LUMINARY Memo #167

To: Distribution
From: B. McCoy, P. Rye
Date: 17 August 1970
Subject: Luminary 1D: Which One, What Kind, How Many?

Luminary 1D will be released for the third time on 19 September 1970; its revision # is 178. The new changes incorporated are PCRs 322, 1056 and 1058. Herewith are the descriptions.

R10 COMPUTATIONS in SERVICER

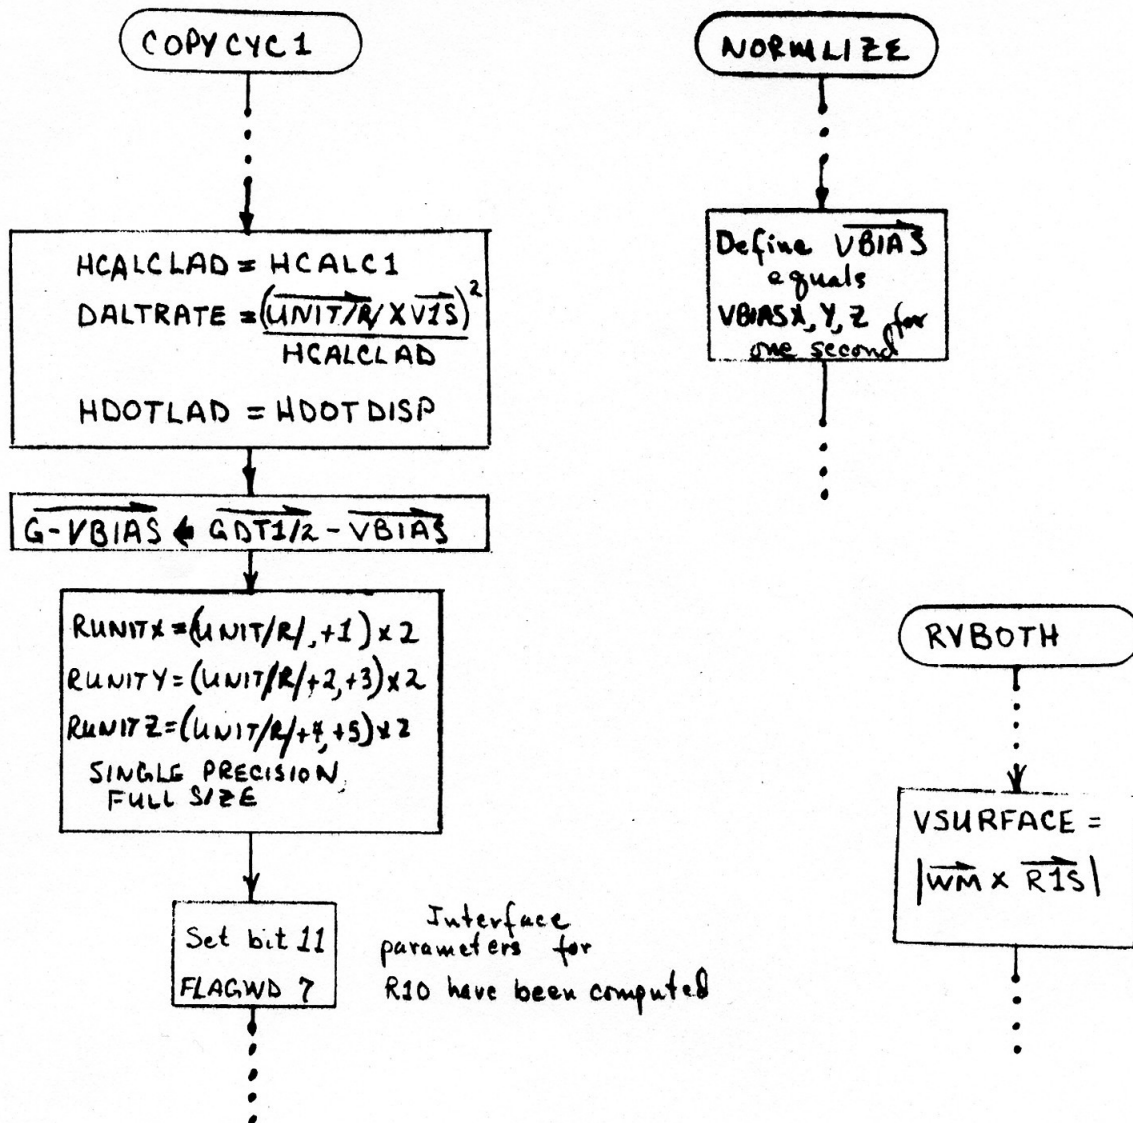
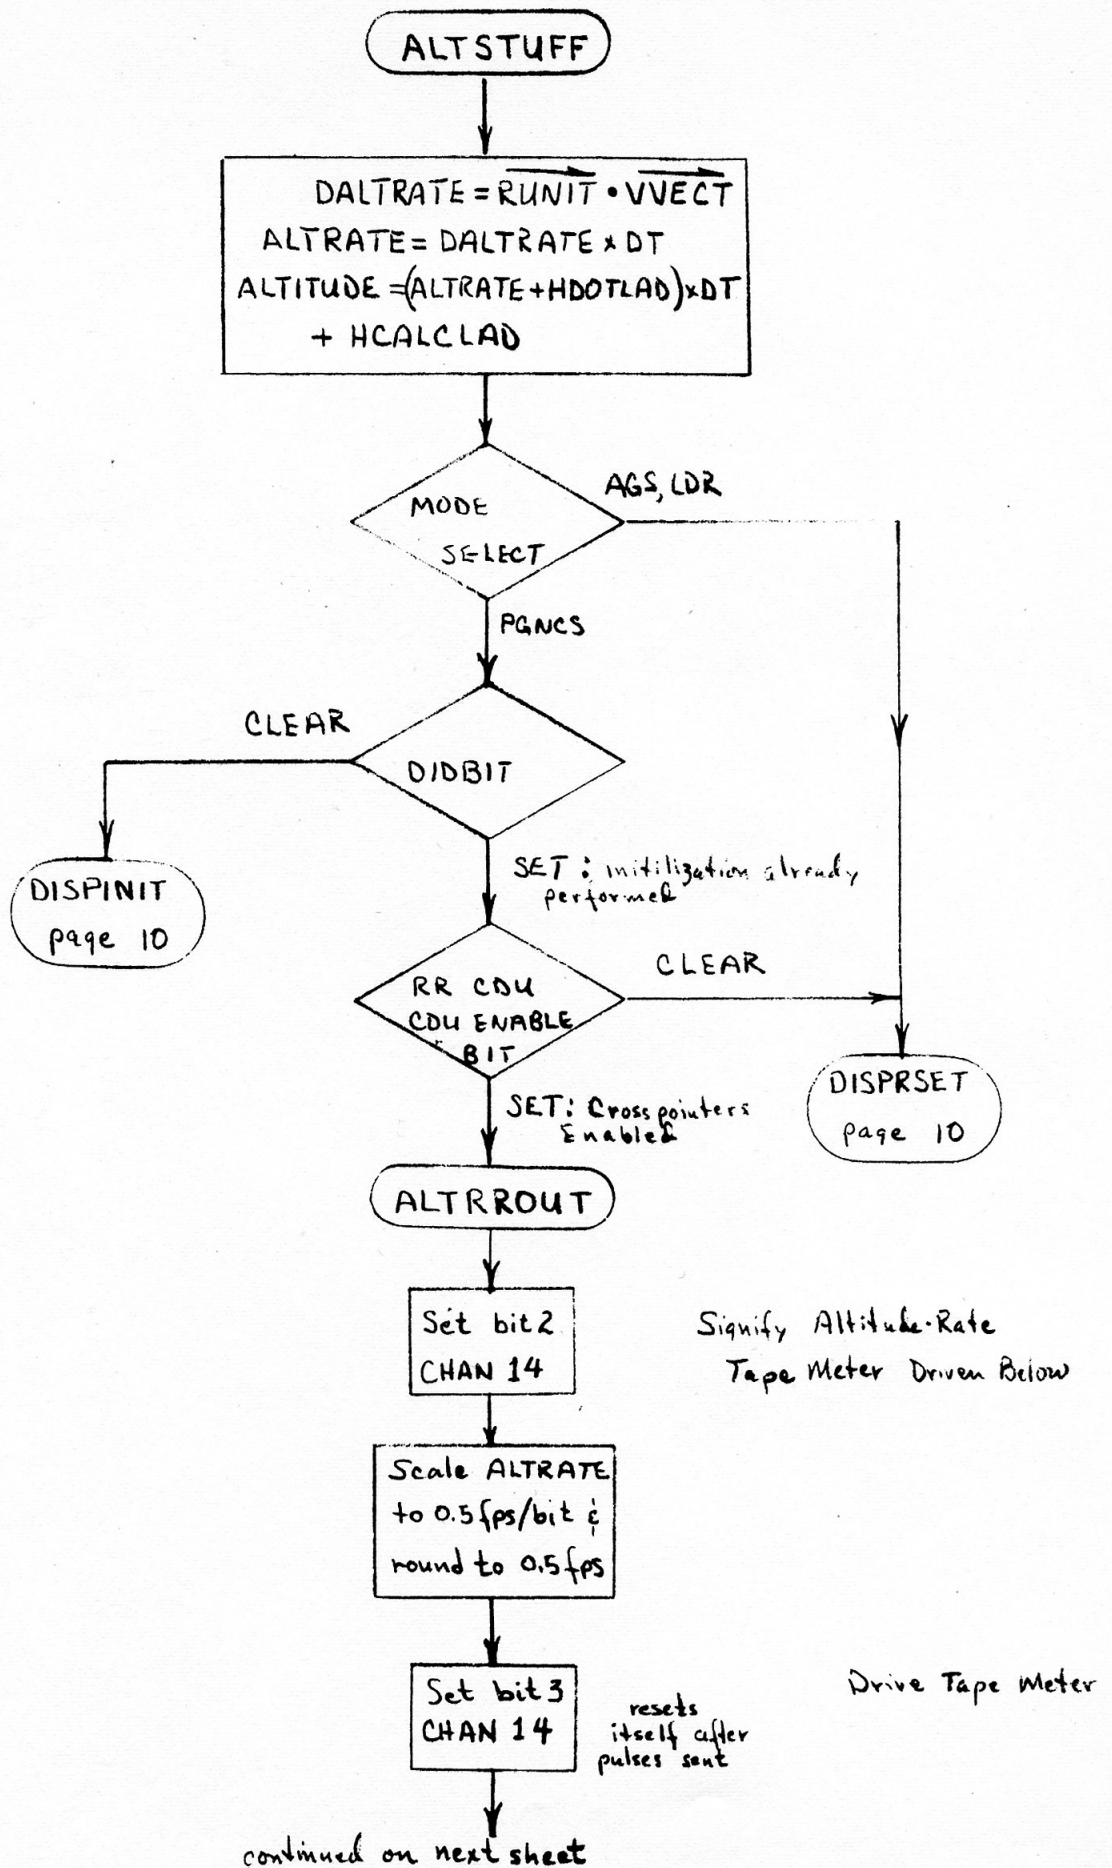
PCR 1058: When it was found that the Landing Analog Displays Routine (R10) gave results with errors up to 3.5 fps in the cross pointer display, a new R10 was suggested to effectively eliminate these errors. In the process the altitude-rate glitch was eliminated. The word saving was 119 words; the new R10 takes 1% longer. The main cause of the errors was the single precision dot products; these were changed to double precision. Also, some computational simplifications were made to the dot products, knowing that the IMU is aligned to the landing site. A PIPA bias correction term is added to increase accuracy; computation of VBIAS formerly done in P66 is now done in SERVICER. Altitude is based on a simpler extrapolation than before. R10 now computes altitude and Alt-Rate every pass (every 1/4 second) outputting Alt-Rate before a 12 cs pause, Altitude immediately after the pause. Flag bit SWANDISP is now set immediately after SERVICER computes the parameters necessary for R10 so that R10 may start near TIG -30 rather than at ignition. The DIDFLAG definition remains the same; just DID the initialization. IMODES33 bit 7 is no longer used. ACB L-11 and Anomaly L-1B-04 were not incorporated into the new R10 as originally conceived, but they are in Luminary 178: The forward velocity for NOUN 60 will be computed if the MODE SELECT switch is not in PGNCS (and incidentally accurate to 0.1 fps); R10 will be initialized if the RR CDU ENABLE bit is removed by e.g. moving the RR MODE switch into and out of LGC.

The R10FLAG has been redefined. When it's set by P12, P70, P71, the inertial Y velocity will be displayed on the lateral velocity cross pointer while the forward velocity crosspointer is set to be zero. The lateral velocity is $VVECT + 2 \text{ minus } VSURFACE + 2; (\text{inertial } (Y) - \text{SURFACE } (Y) \text{ velocities})$.

Flow Charts for R10 and its interface parameter computation are attached. For more details see Luminary Memo #162 by Don Eyles. This memo superceeds Memo #162 where differences occur.

Changes to other areas due to R10 design:

1. downlist neumonic changes

LATVEL to LATVMETR

FORVEL to FORVMETR

2. VBIAS calculation moved from STRTP66A into NORMLZE;
parameter GHZ removed
3. For erasable overlay purposes ZAXIS computation moved to Ascent
Guidance from P12 initialization.
